RE: Brushy Brook Residential Subdivision
Hopkinton, Rhode Island
DE Project No. 1193-001

DiPrete Engineering has received the comments from the town peer review consultant, Crossman Engineering, dated August 19, 2021. We have reviewed these comments and offer the following in response. The original comments are provided in italics with responses in bold, and Crossman follow-up comments from 2/22/22 in red. DiPrete response have been provided in green.

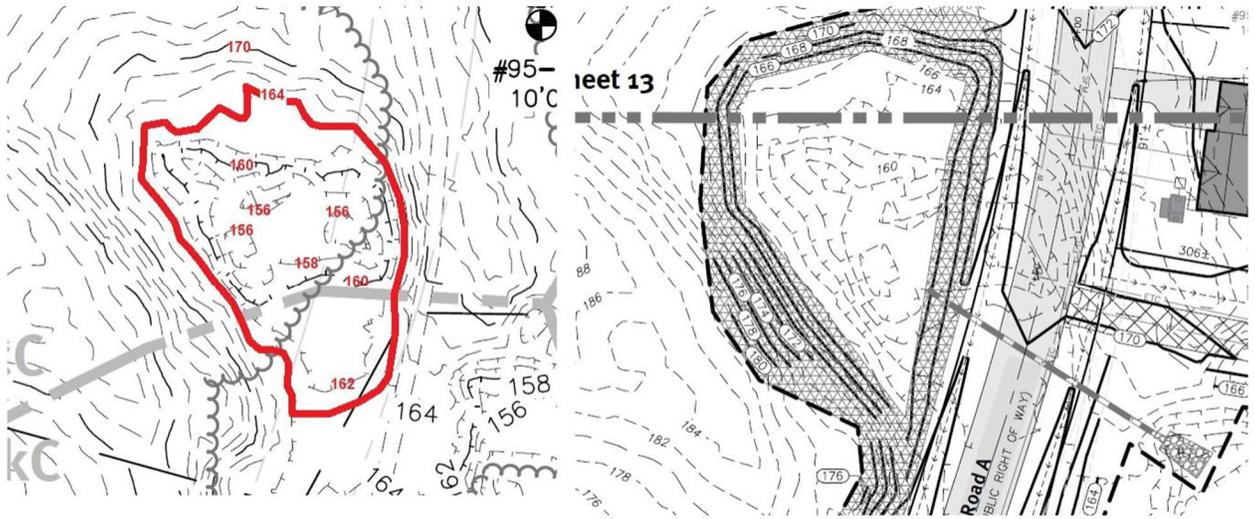
22. *No groundwater mounding analyses were provided for infiltration basins with less than 4 feet of separation to the groundwater table. This analysis is needed to confirm the adequacy and operation of the systems.*

Based upon the revised Drainage Report, it appears that all of the proposed infiltration basins (WQ and QP Ponds) take credit for infiltration and attenuation for up to the 100-year storm. Therefore, for basins where less than 4 feet of separation to the groundwater table is provided, a mounding analysis is required to demonstrate that the underlying groundwater level will not mound and reduce the infiltration rates during the larger storms. For example, the revised analysis indicates that Pond G (Node 362) infiltrates 3.782 acre-feet (164,744 cubic-feet or 75% of inflow) and only 1.280 acre-feet (55,757 cubic-feet or 25% of inflow) discharges through the outlet structure during the 100-year storm event. The purpose of this analysis is to verify that the groundwater mound that forms under the infiltration basins will not elevate into the basin or reduce the infiltration rate (attenuation) during the larger magnitude storm events. The outcome could alter the future peak flows and total runoff volumes and is needed to document conformance to Section 17.5 of the Town Regulations.

DiPrete Response 4/12/2022: DiPrete Engineering reviewed groundwater separation for all ponds. Ponds with less than four feet of separation are Water Quality Pond C, Infiltration Pond D, Water Quality Pond F, Infiltration Pond F, and Infiltration Pond G.

Water Quality Pond C, Infiltration Pond D, Water Quality Pond F, and Infiltration Pond G have been revised to provide four feet of separation to the seasonal high groundwater table.

Infiltration Pond F has been revised and now only provides two feet of separation to the seasonal high groundwater table. Per the RISDISM, a Qp pond must have a minimum of 2' of separation. Due to the mounding, the infiltration rate of Pond F has been reduced in HydroCAD to ensure the mound does not impact the 1 year storm. For the 2 year, 10 year, 25, year and 100 year storm events infiltration has been removed in HydroCAD. This creates a conservative model that doesn't account for any infiltration in the upper storms when some will occur. See Appendix C of the stormwater report for mounding calculations.

Existing-Existing Depression

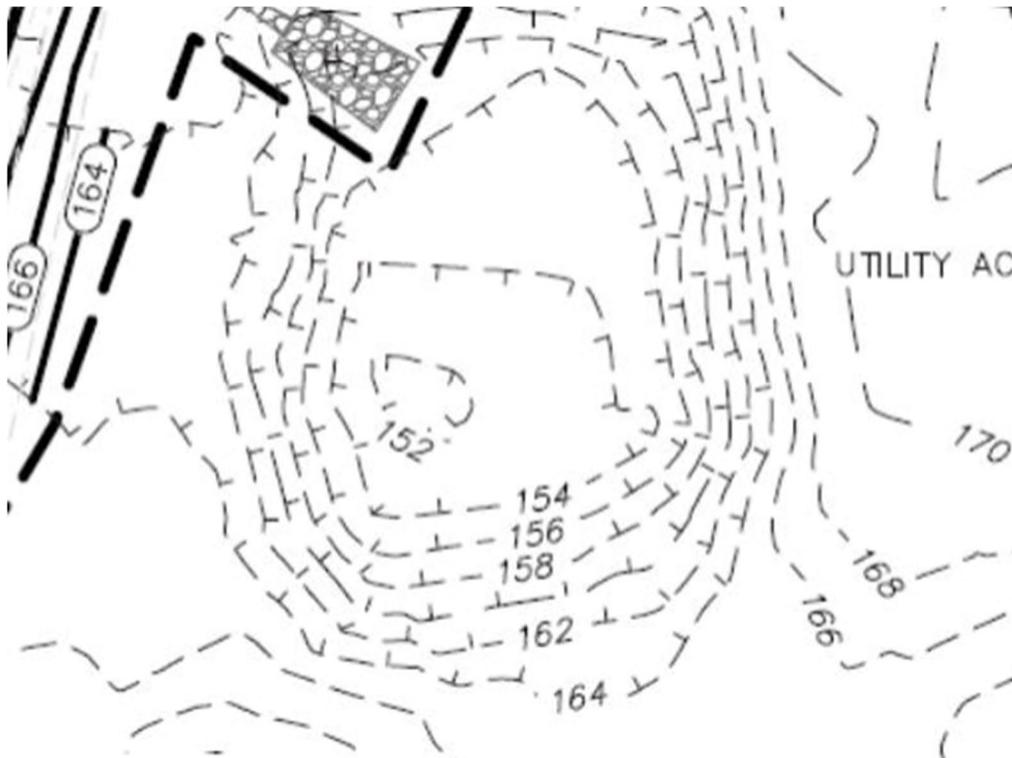
23. *The Post-Development Conditions model includes an existing depression (Pond 226, "Existing Depression STA 7+00"), which takes credit for the available stage-storage-discharge of an existing depression area. Although the grading of the depression is modified from existing to proposed conditions, the stage-storage-discharge of the existing depression is not included in the existing conditions analysis. The model should include this depression in the existing conditions model. All well-defined existing depressions must also be accounted for in the existing conditions model.*

Crossman Response 2/22/22: The reply contradicts the Site Plans and Surveys, therefore is incorrect. Existing depressions of up to 12 feet deep are shown on the Existing Conditions

Topography. These depressions provide storage and infiltration of existing runoff and need to be addressed in the Existing Conditions Modeling. Otherwise, the actual change to runoff under future conditions remains unaddressed. A potential increase in runoff towards abutters and public roads is a Town concern and unrelated to the issuance of a RIDEM Permit.

DiPrete Response 4/12/2022: The depressions have been added to the pre and post development models.
